Subject: Duke Energy Corporation  
Oconee Nuclear Station, Units 1 and 2  
Docket Numbers 50-269, 50-270, and 50-287

Technical Report NFS-1001A, Revision 5,  
January 2001, *Reload Design Methodology*

**DUKE POWER COMPANY  
OCONEE NUCLEAR STATION  
RELOAD DESIGN METHODOLOGY  
Technical Report NFS-1001A**

**JANUARY 2001  
REVISION 5**

Figure 1-1

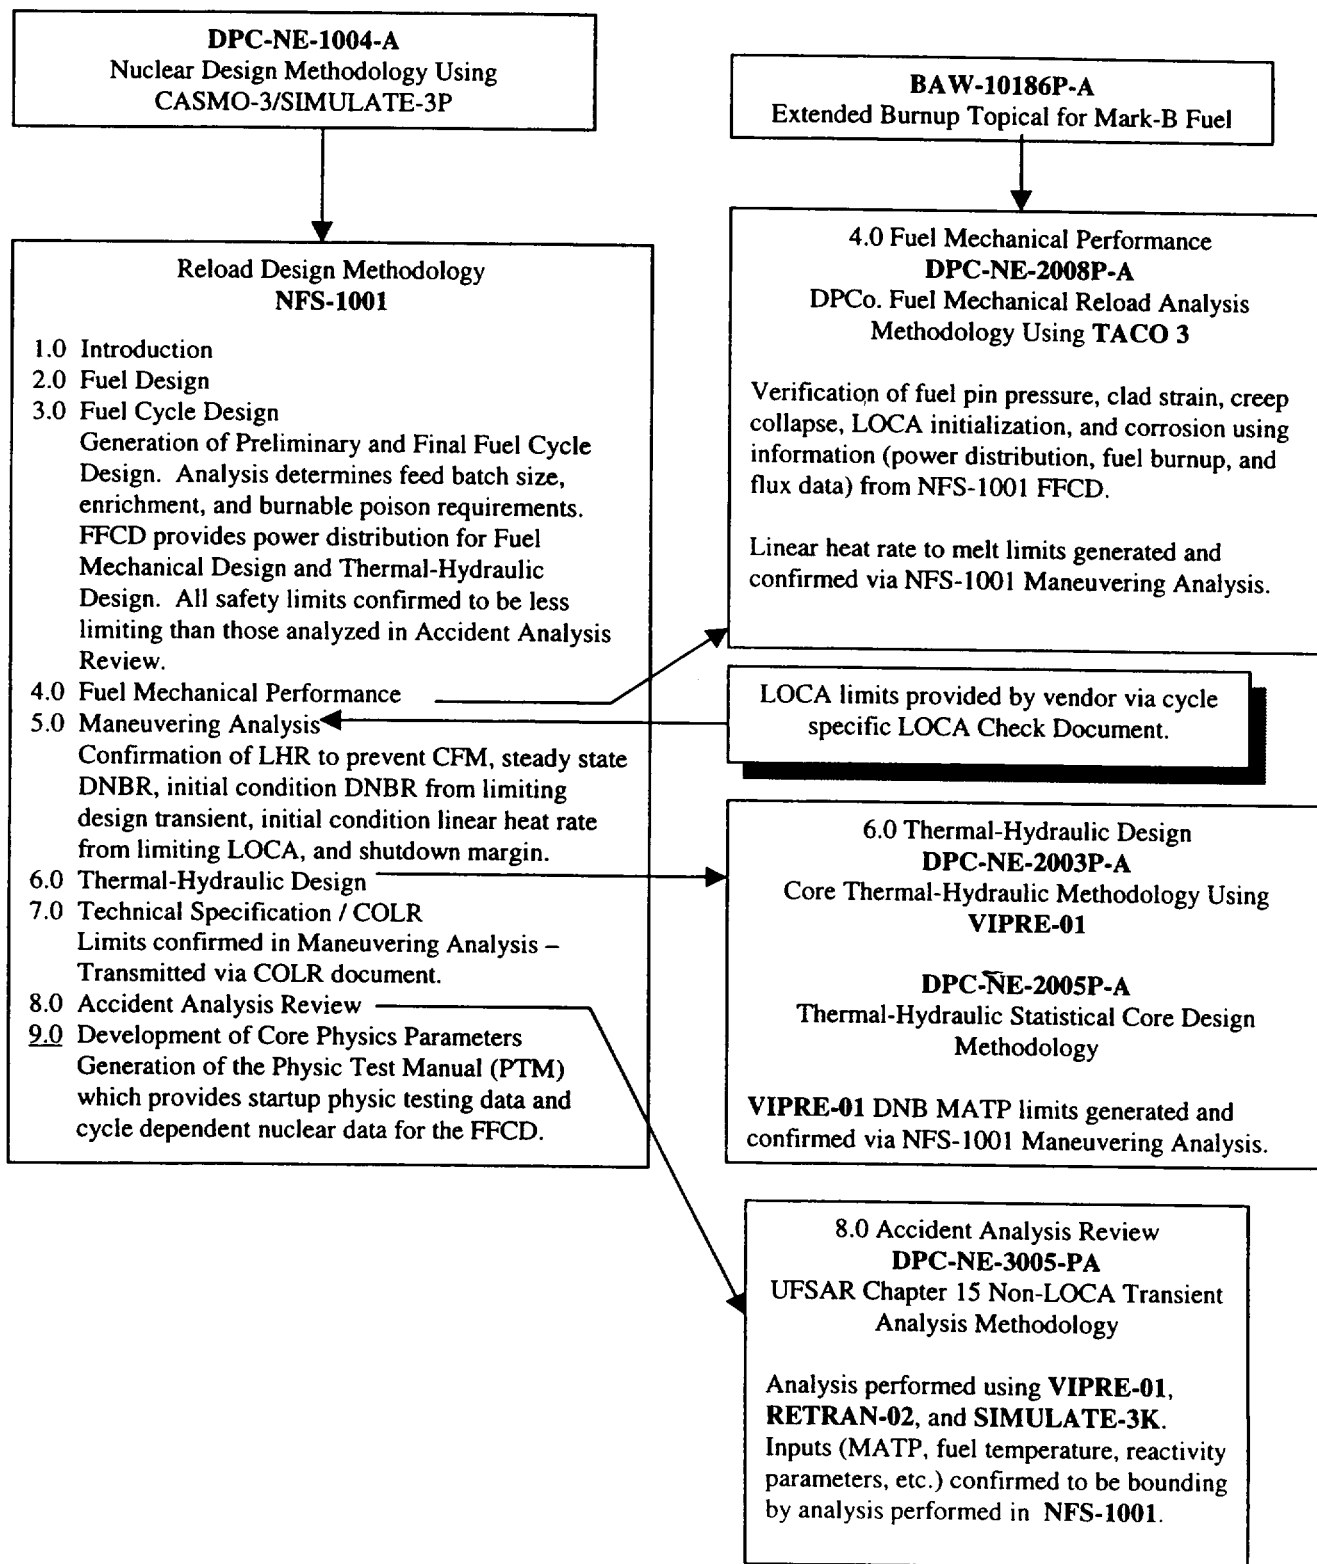
12. The methodologies used to develop the core physics parameters in chapter 9 need to be stated or referenced. (Page 42)
13. Figure 1-1 should reference the approved version of DCP-NE-3005. (Page 5)

13. Question: Figure 1-1 should reference the approved version of DPC-NE-3005. (Page 5)

Response: Figure 1-1 has been revised as stated.

Figure 7-4

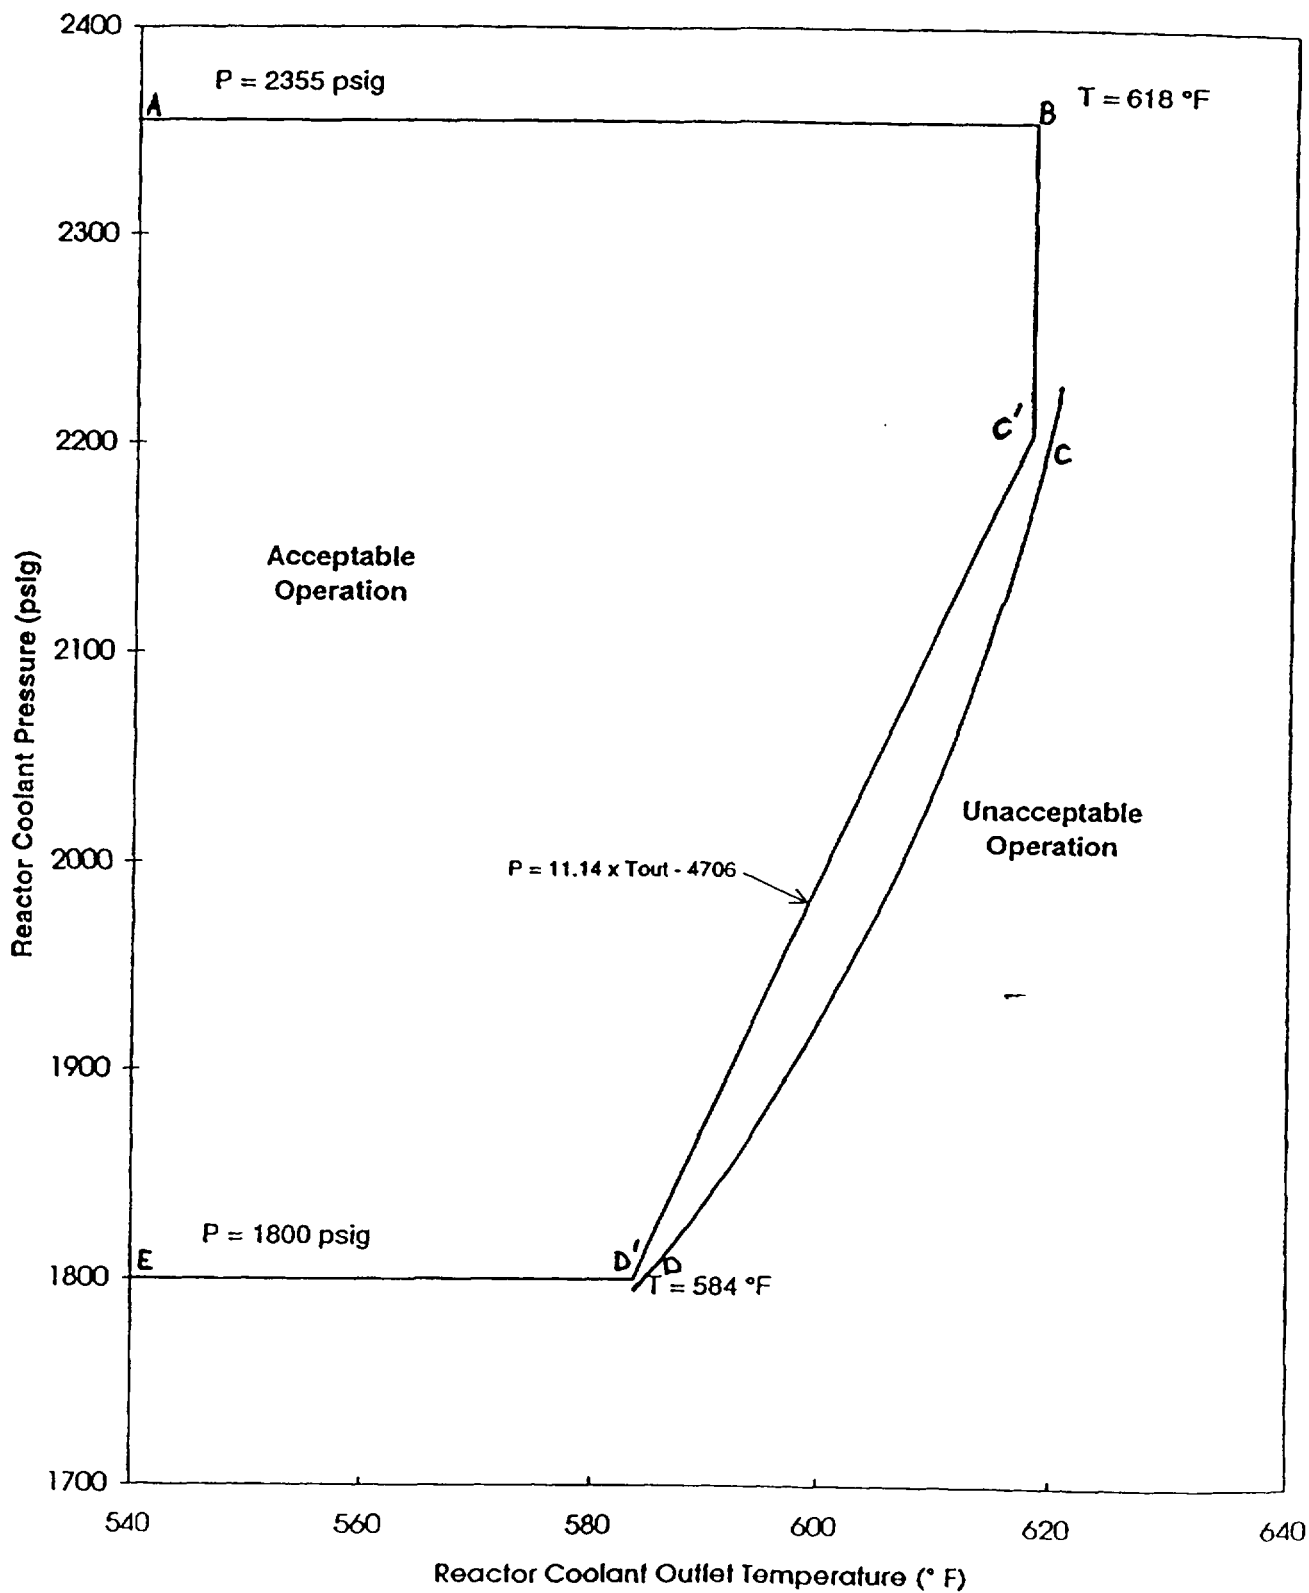
In determining the reactor protection system P-T set points, the applicant stated that the RCS high pressure trip set point was 2356 psig. In the Technical Specifications for Oconee Units 1, 2, and 3, the high pressure trip is at 2300 psig. Correct this discrepancy.

- 1) Paragraph 2, page 7-0
- 2) Table 7-1, page 7-16
- 3) Figure 7-4, page 7-20

Figure 7-5

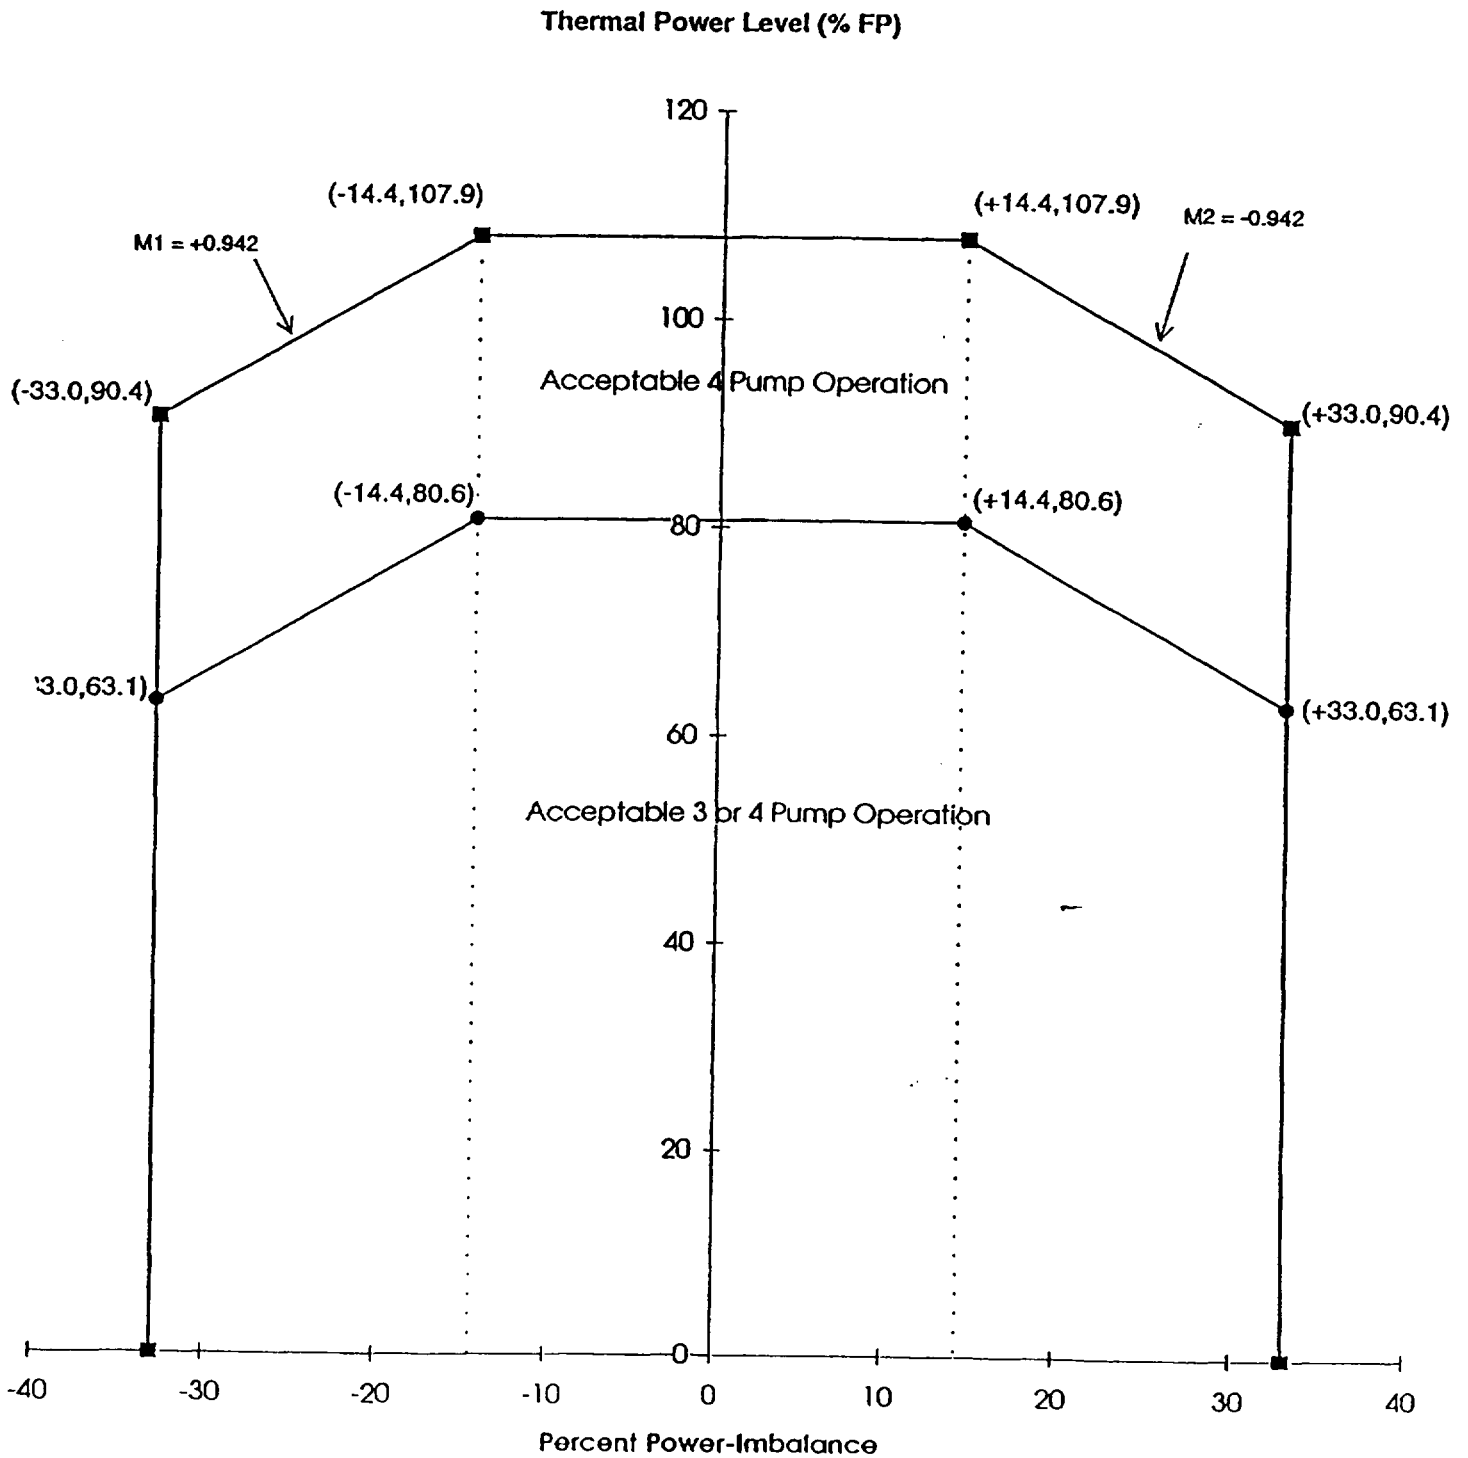
14. For the determination of the power-flow-imbalance trip setpoint, how is the allowable power-to-flow ratio obtained? Figure 7-5 displays the power-power imbalance portion of the trip function, however, it does not appear to display the power-to-flow ratio portion of the trip function. Please include an example display of the power-to-flow ratio portion of the trip. (Page 25)

14. Question: For the determination of the power-flow-imbalance trip setpoint, how is the allowable power-to-flow ratio obtained? Figure 7-5 displays the power-power imbalance portion of the trip function, however, it does not appear to display the power-to-flow ratio portion of the trip function. Please include an example display of the power-to-flow ratio portion of the trip. (Page 25)

Response: DPC-NE-2003P-A (reference 5) describes how the analysis of the loss of flow event is utilized to obtain the power-to-flow ratio. This is illustrated in Figure 7-5 as the reduction in allowable power level from four-pump flow to three-pump flow.

Figure 4-1. (FSAR Figure 14-1)

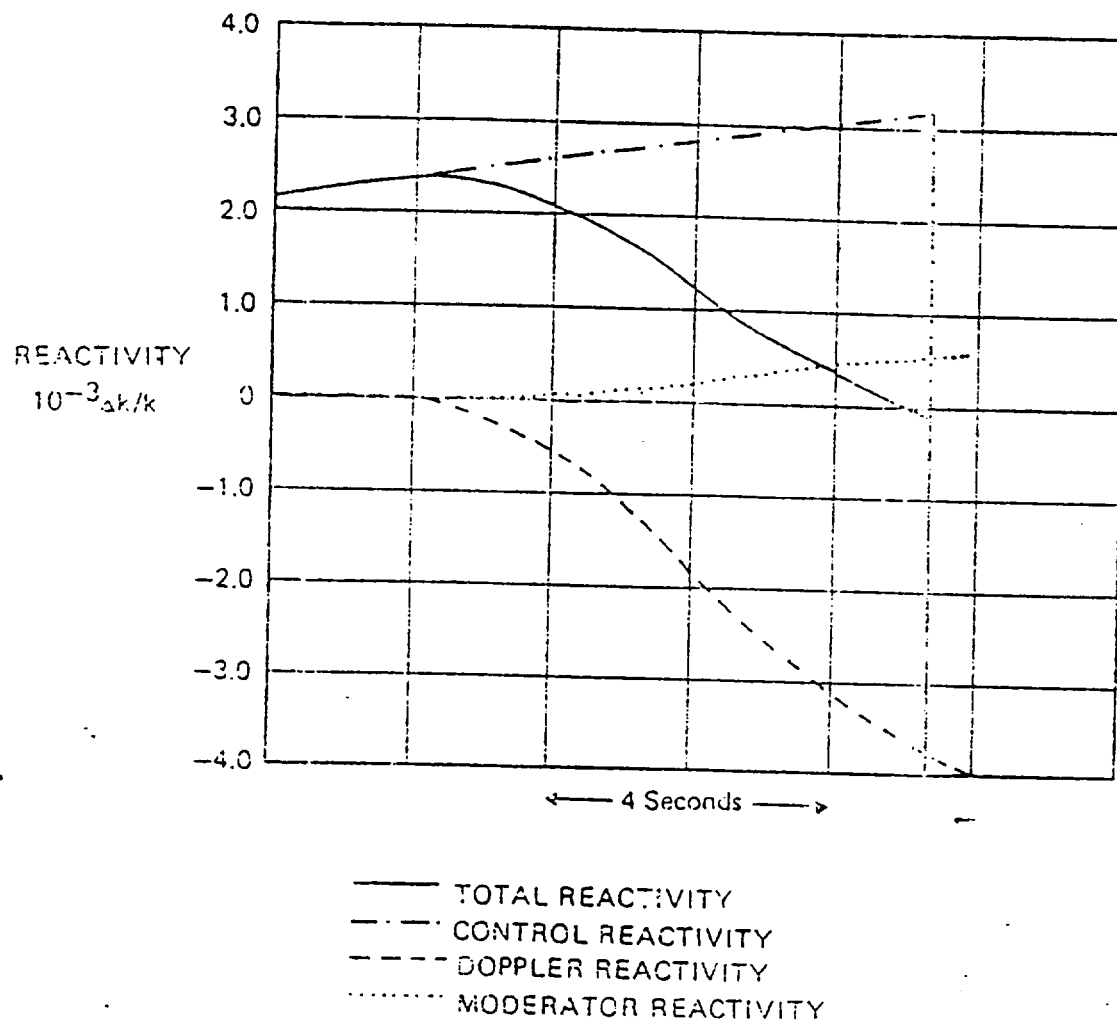
Question 4 requests additional information for the start-up accident concerning the variation of the components of the reactivity response. These parameters are an intermediate output of the analysis whose response is indicated by other documented parameters such as power level, but are not normally included in the analysis documentation. However, the components of the reactivity response are determined by the parameters which are reviewed and shown to be within the bounds of the FSAR analysis. The reactivity response determined by those parameters remains valid until the value of a parameter is no longer bounded for a reload core. The safety review methodology of Section 8 assures the identification of all pertinent reload core parameters affecting the reference safety analysis, confirmation of the validity of the reference safety analysis for the reload core, and the resolution of any non-conservative parameter.

In order to respond to the question, the variation of the total reactivity and its components were calculated from the results presented in FSAR Figures 14-1 and 14-2, utilizing the analysis assumptions specified in the FSAR. The variation of the total reactivity during a startup accident is the sum of three reactivity effects. The withdrawal of the control rod banks adds positive reactivity which causes the neutron power level to increase and raise the average core temperature. The increase in fuel temperature causes a negative reactivity feedback due to the negative Doppler coefficient. The increase in power level increases heat transfer from the fuel to the coolant, resulting in an increase in moderator temperature. This causes a positive reactivity feedback since a positive beginning of cycle moderator coefficient is assumed. The transient response is primarily determined by the rate of positive reactivity addition from the withdrawal of rods, and the Doppler feedback which slows or terminates the nuclear excursion. The moderator feedback has a smaller effect. Figures 4-1 and 4-2 show the variation of the reactivity consistent with FSAR Figures 14-1 and 14-2 respectively. It should be noted that these figures do not represent the first 10 seconds of the transients, considering that the initial conditions are  $10E-9$  rated power and 1% k/k subcritical. Figures 4-1 and 4-2 illustrate the time interval of greatest interest during the transient, Figure 4-1 is the same scale as Figure 14-1, and Figure 4-2 is the first one second of the response in Figure 14-2. For both transients the reactivity addition for the first 10 seconds following initiation of rod withdrawal would only cause a reduction in the subcriticality margin.

Figure 5-1 (FSAR Figure 14-9)

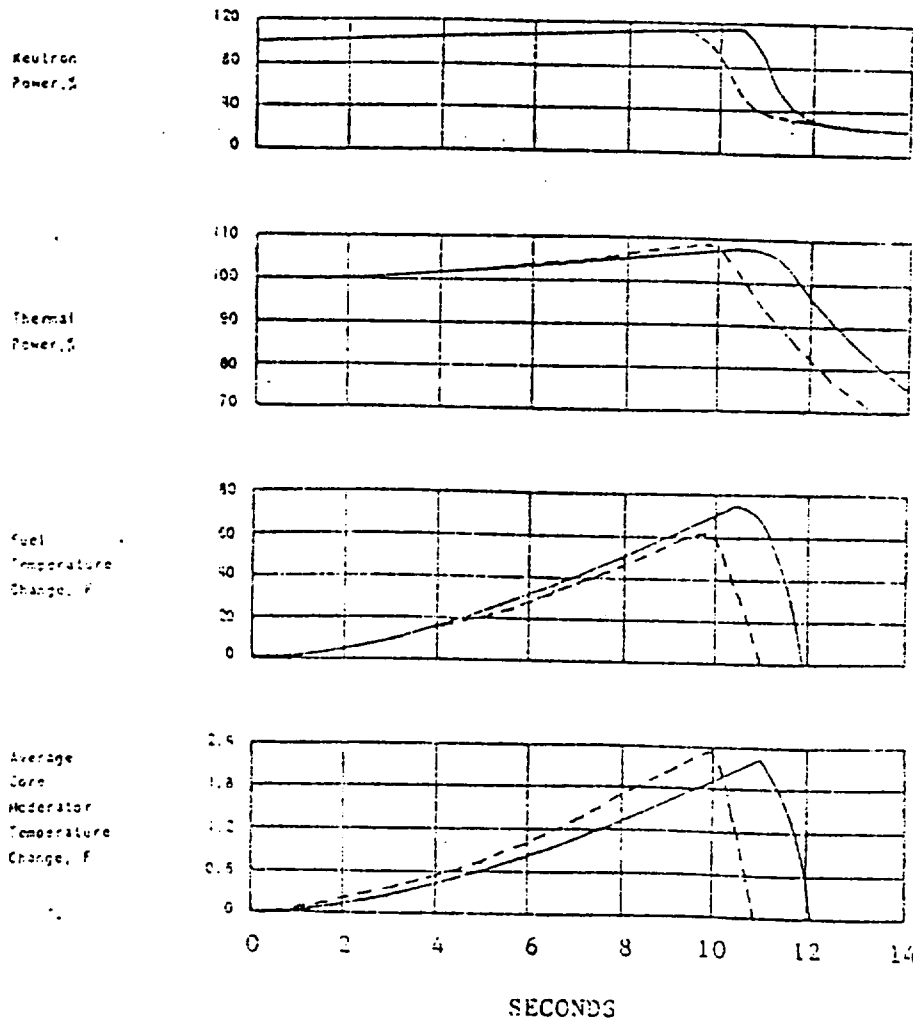
Q. 5. Paragraph 8.3.3. Rod Withdrawal Accident at Rated Power Operation

Give the variation of the reactivity as in 4. above.

A. 5. The reactivity response of the rod withdrawal accident at rated power simulation performed by B&W and used in the original FSAR analysis is not available. In order to respond to the question a similar analysis was performed by Duke Power Company using the RETRAN code and matching as accurately as possible the modeling assumptions of the original analysis. Figure 5-1, a revised FSAR Figure 14-9, shows the comparison between the original analysis (solid lines) and the new analysis (dashed lines). No attempt was made to match the results of the original analysis, the intent being to match the assumptions and initial conditions. The similarity between the results of the two analyses supports the conclusion that the reactivity response of the new analysis shown in Figure 5-2 is representative of the original analysis.
